V2500-A1/A5 SERIES PROPULSION SYSTEMS SERVICE BULLETIN

This document transmits Revision 1 to Service Bulletin V2500-NAC-71-0227

NACELLE – POWERPLANT – FAN COWL DOOR LATCH HANDLES – APPLICATION OF FLUORESCENT PAINT

Painting of Fan Cowl Door Latch Handles
Figure 1

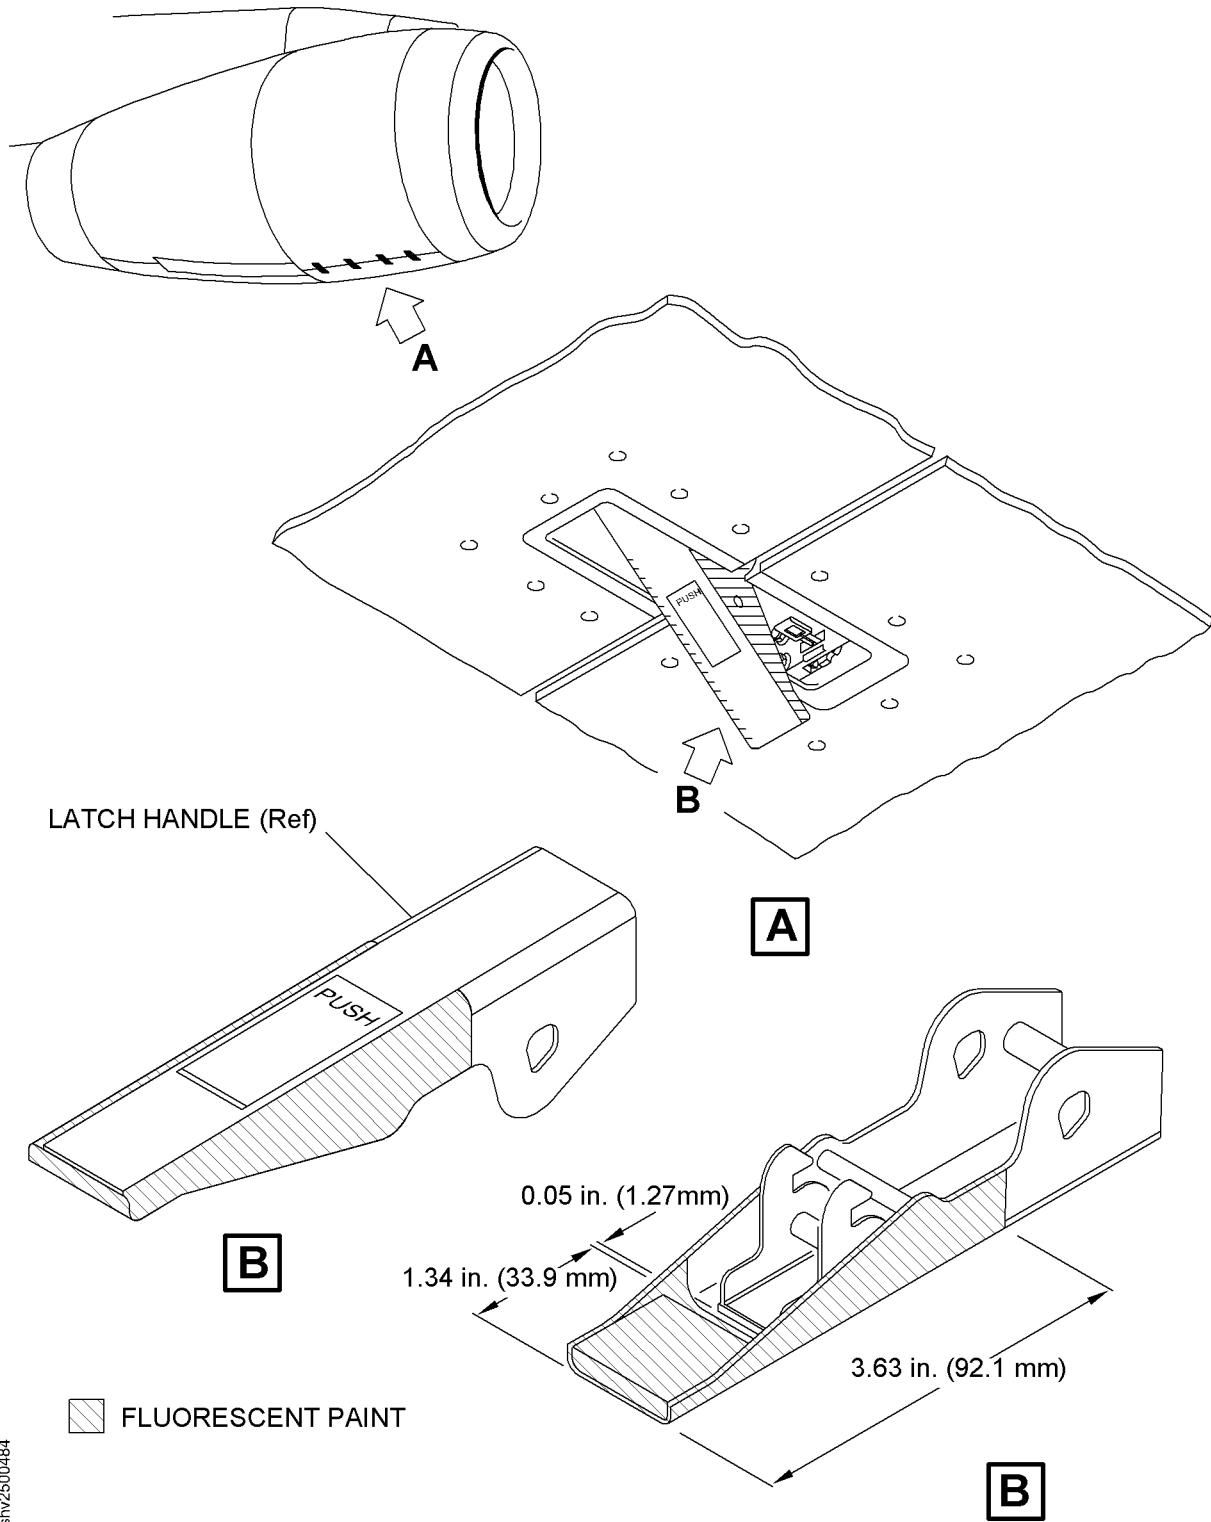
The change introduced by this Service Bulletin is the addition of red/orange fluorescent paint to the four Fan Cowl Door Latch handles on the right hand door on both engines.

- (4) Position Latch handles at a suitable angle for rework of paint area as shown (Refer to Figure 1).

- (a) Apply paint with a brush to the latches (shaded area) as shown (Refer to Figure 1).
